Gloucester Gas Project
AGL Gloucester L E Pty Ltd
24 May 2010

Gloucester Gas Project

Submissions Report

Figure 9: Visual Assessment Map

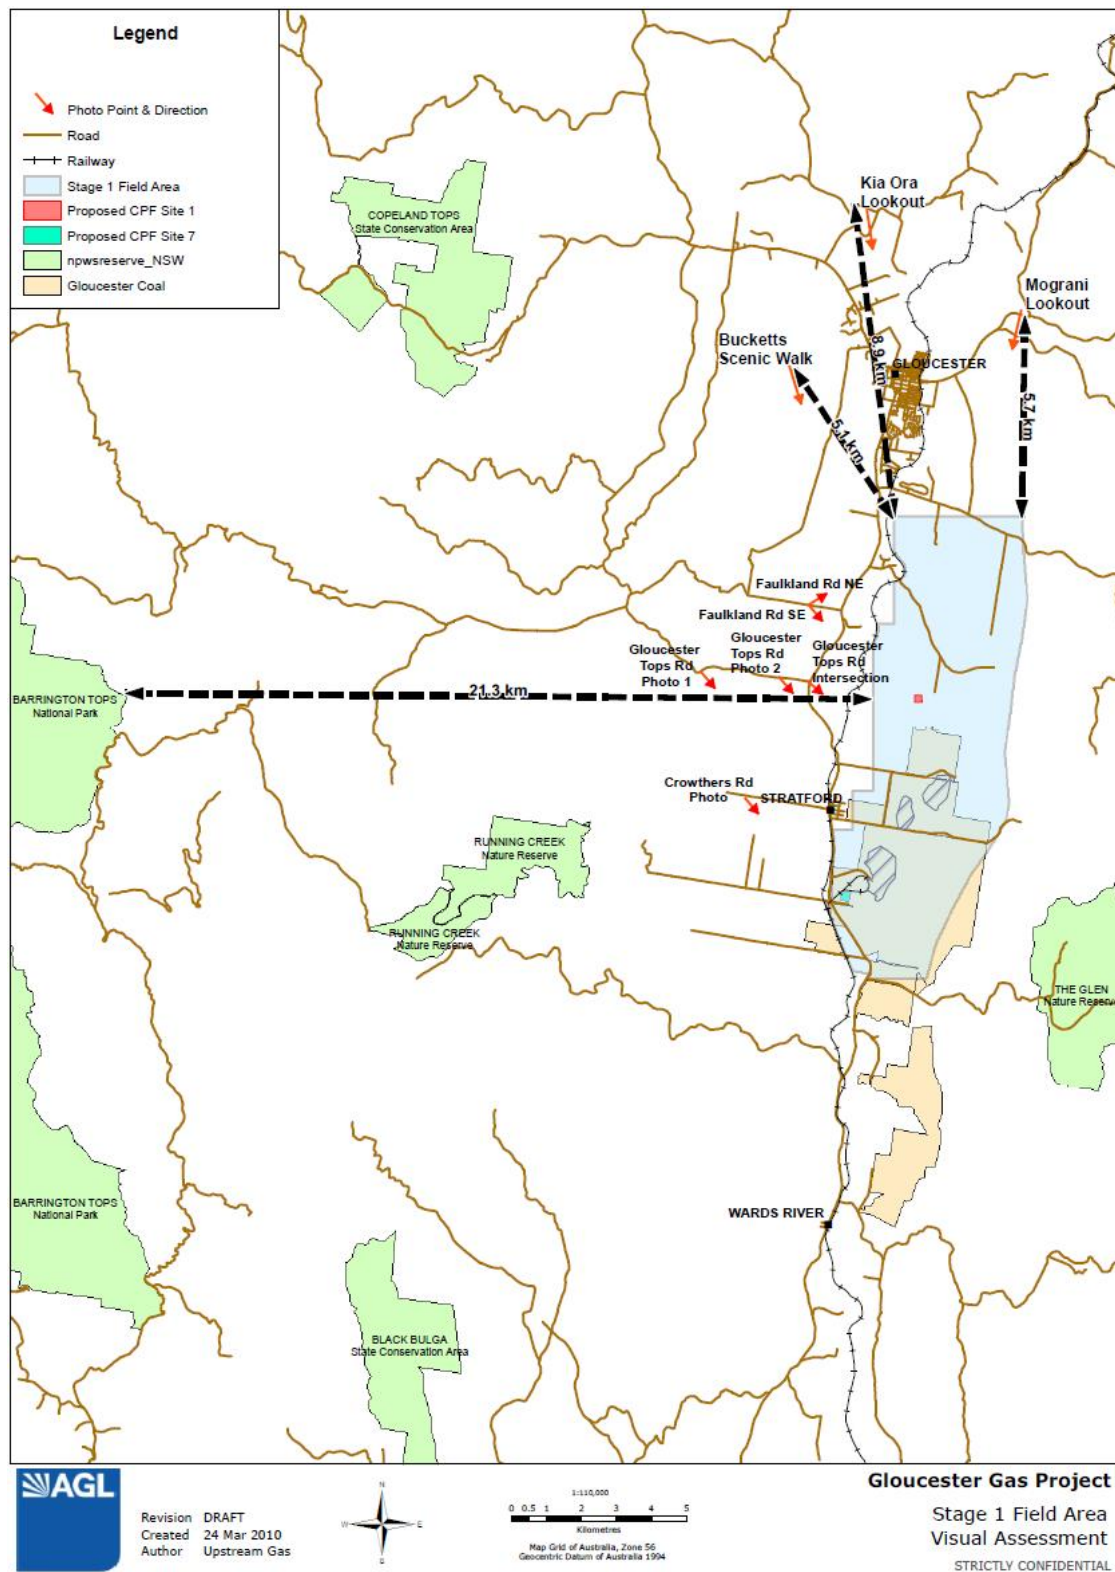
Tourist related walking tracks, bike trails, lookouts and picnic areas etc. are located in and around the Vale. Most of these facilities are located within Barrington Tops National Park, located some 21km west of the proposed project area. Others such as Kia Ora Lookout and Bucketts Scenic Walk are located approximately 9km and 5km from western boundary of the project area respectively. Mograni Lookout and Oakey Falls are located approximately 6km north and 4km north-east of the Project Area. Refer to Figure 5 below. After approximately 500m the well heads blend into the landscape. Whilst these locations are elevated and afford views of the valley, distances from the Project Area and the small scale of well heads are such that their visual impact within the landscape is likely to be very limited.

Figures 10 to 18 show the above mentioned vantage points overlooking the Project Area, which are identified in the Visual Assessment Map shown in **Figure 9**. It should be noted that as Oakey Falls is located on private property and is not a tourist location it is not included as one of the vantage points.
